PROJECT:	61 High Lane, Chorton		
CLIENT:	Mr J. Kennedy		
DRAWING:	Proposed Street Scene - Stockton Road		
DRAWN BY:	GC	CHECKED BY:	--
DATE:	02/07/2021	SCALE:	1:100 & 1:25 @ A1
STATUS:	Planning		
DRAWING NO:	1000-P-900	REVISION:	A

Proposed Street Scene - Stockton Road
Scale 1:100

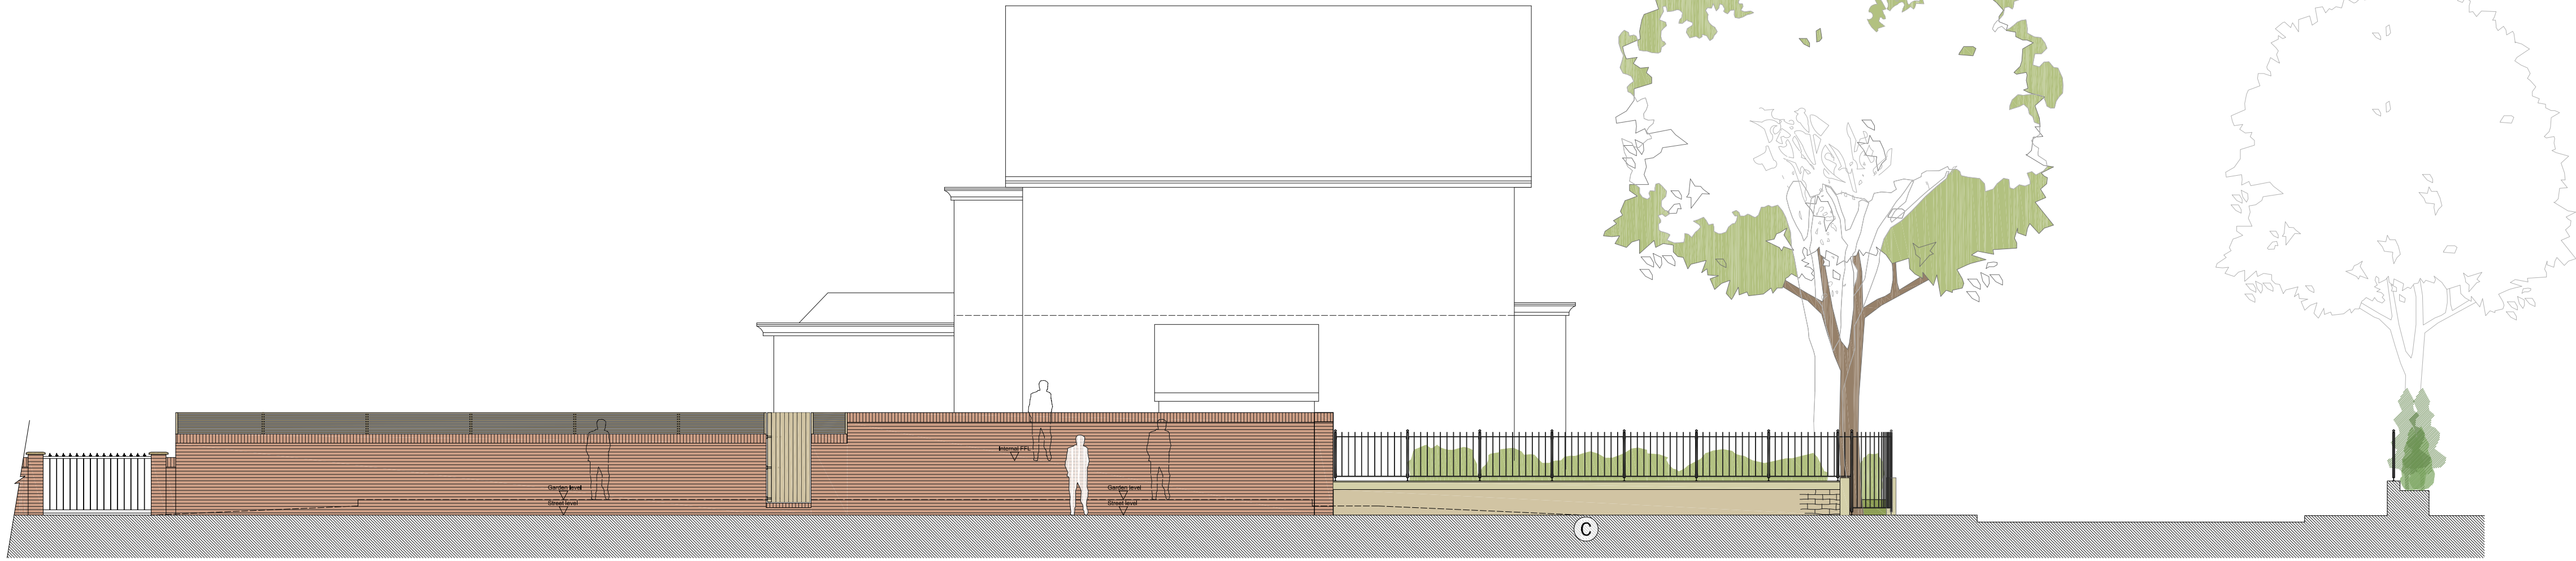
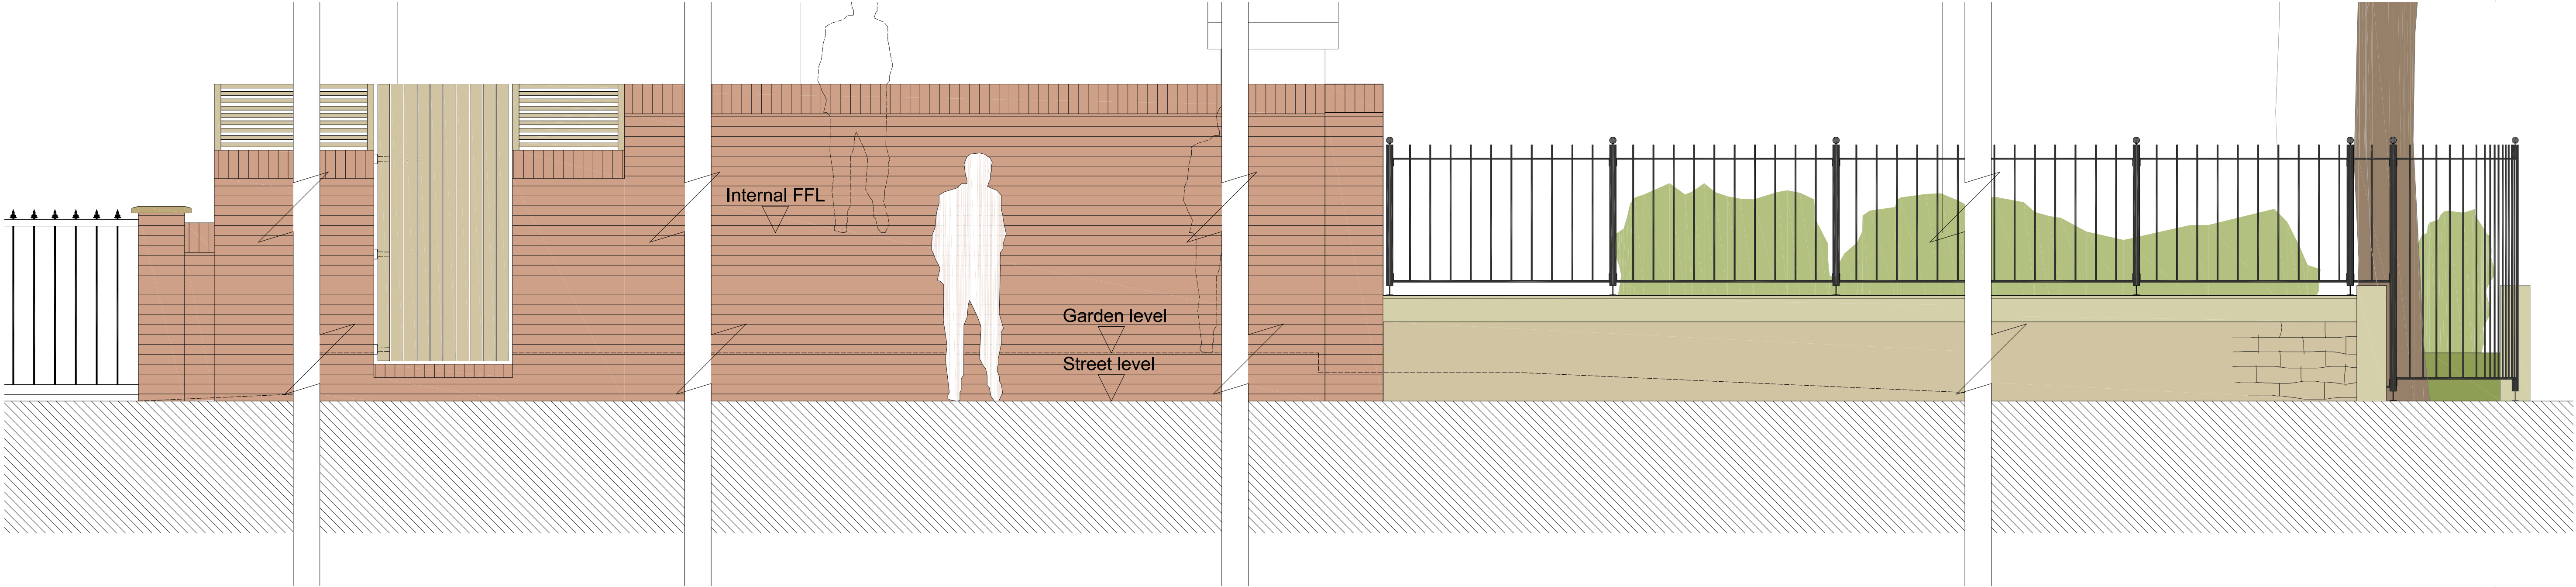
A	07/08/2021	Driveway position amended in accordance with sketch drawing 1000-P-900-2 - sketch site layout plan as agreed by MCCS Highway Engineer. Gate and gate posts moved 2m back from the site boundary in order for vehicles entering and leaving the premises to wait for on coming vehicles and pedestrian traffic, whilst remaining within the site boundary and so as not to impede on the foot traffic along the public footpath. Boundary treatment (adapted to the site scale wall and metal railings) amount of landscaping (proposed in acc. with NMS statement & TP scheme) and hedgerow and driveway notation added.	GC	
REV	DATE	AMENDMENT	BY	CHKD
